**SUBDIVISION COMMITTEE
METROPOLITAN AREA PLANNING COMMISSION**

STAFF REPORT

(Final Plat, Preliminary Plat approved June 24, 1993)

CASE NUMBER: S/D 93-36 - COLBERT ADDITION

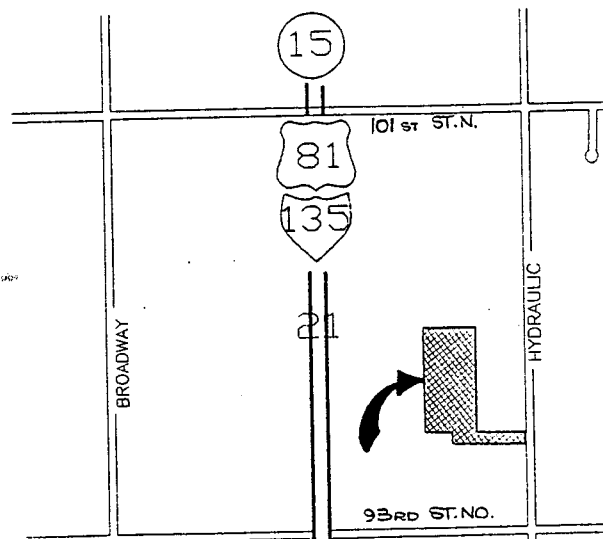
NOTE: When the preliminary plat for this site was reviewed, in order to allow the four proposed lots to contain 5-acres each as is needed for the use of lagoon sewer systems, the Subdivision Committee approved the use of a right-of-way agreement or in essence an access easement rather than the outright dedication of public street right-of-way. Such action, therefore, waived the Subdivision Regulations as regards required lot sizes and dedication of street rights-of-way for multiple lot Additions. However, even with the allowance for use of an access easement and the calculation of such area as a portion of the platted lots, these lots are still at approximately 4.9 acres, below the required standard of 5 acres. Further, while Colbert Court appears to be the street needing to be considered as an access easement in order to meet required lot sizes, the East-West section of Colbert could and should be dedicated by the plat as an outright street dedication.

A. Since neither municipal water nor sanitary sewer is available to serve this property, the applicant shall contact the Environmental Health Division of the Health Department to find out what tests may be necessary and what standards are to be met for approval of on-site sewerage facilities and water wells. A memorandum shall be obtained specifying approval. This approval shall require waiver of the 5-acre requirement for the use of lagoon sanitary sewer systems.

B. On the final plat tracing, the east-west portion of Colbert St. shall be indicated as an outright street dedication. The plat's text shall therefore indicate the dedication of streets and the face of the plat shall clearly indicate this as a public street (not as a part of Lot 4, but as a street separate from the lot(s) and with dashed lines at the street's west end and where it intersects Hydraulic).

C. Since this plat cannot be the means for establishing the north-south access easement (Colbert Ct.) and approval of this plat is dependent upon the County Commission accepting this easement and (agreement), the applicant shall either submit the agreement to the County for approval and recording, with the final plat tracing not being forwarded until the agreement is accepted and recorded and the recording information shown on the final plat tracing. However, if the agreement is submitted with the plat, approval of the plat will be subject to the County's acceptance of this agreement. If the County does not accept this agreement (easement), a revised plat will need to be submitted and first approved by the Subdivision Committee.

D. The applicant shall guarantee the installation of Colbert and Colbert Ct. to the suburban street standard. Since a portion of these streets are expected to be private, the applicant shall meet with County Engineering to determine the appropriate means for guaranteeing the installation of the streets.

- E. The utility representatives need to indicate if the 20-foot utility easement along the south line of Lot 4 should be continued eastward or across the area shown as Colbert Court. That is, since Colbert Ct. is being granted as a "roadway" easement, does a utility easement, if needed, need also to be shown within the area of the right-of-way agreement.

- G. As indicated by the platting binder, KG&E, a Rural Water District, and Ingress-Egress easements are potentially located on this site. The applicant shall be prepared to indicate if these easements are located on this site and if they are, the final plat tracing shall show these easements along with their recording information. Copies of these easements shall also be submitted to Planning for the plat file.

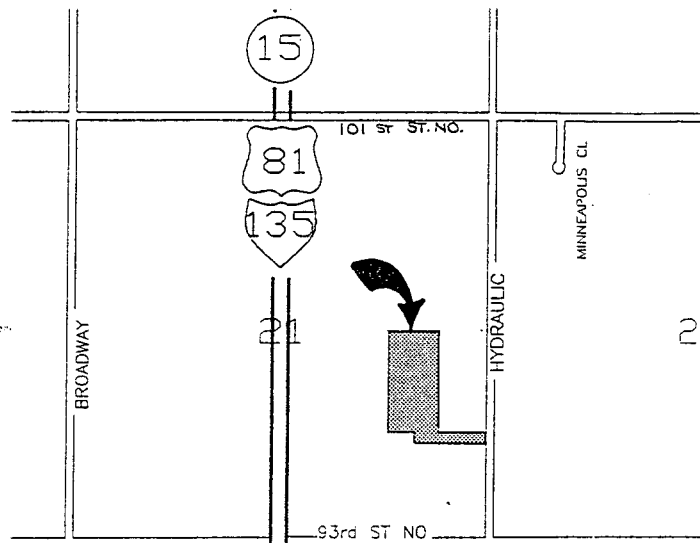
- A. As indicated by Section 7-204 (T) of the Subdivision Regulations for multi-lot residential subdivisions proposing to use individual sewage lagoons, lot sizes shall not be less than 5 acres and this is to be exclusive of street right-of-way. Based on this requirement, this site should either be expected to obtain approval for the use of septic systems or the final plat shall be submitted with no more than three (3) lots, each 5-acres or larger.

- B. Since neither municipal water nor sanitary sewer is available to serve this property, the applicant shall contact the Environmental Health Division of the Health Department to find out what tests may be necessary and what standards are to be met for approval of on-site sewerage facilities and water wells. A memorandum shall be obtained specifying approval.

- C. Due to the existing development in the area of this quarter section and the Interstate that borders this quarter section's western line, the street being platted by this Addition (Colbert) should be continued, or at least provided the possibility to continue westward of this site. To allow for this, the final plat shall indicate the dedication of right-of-way along that portion of Lot 4 which now extends west of Colbert Court.

- D. The applicant shall guarantee the installation of Colbert (from Hydraulic to Colbert Court) and Colbert Court to the suburban street standard.
- E. The final plat tracing shall indicate angles or bearings for the perimeter of this plat.

- F. As required under County "R" zoning, a 30-foot building setback should be indicated on the final plat rather than a 25-foot setback.
- G. On the final plat, the street name Colbert shall also be indicated in the east-west portion of this street.
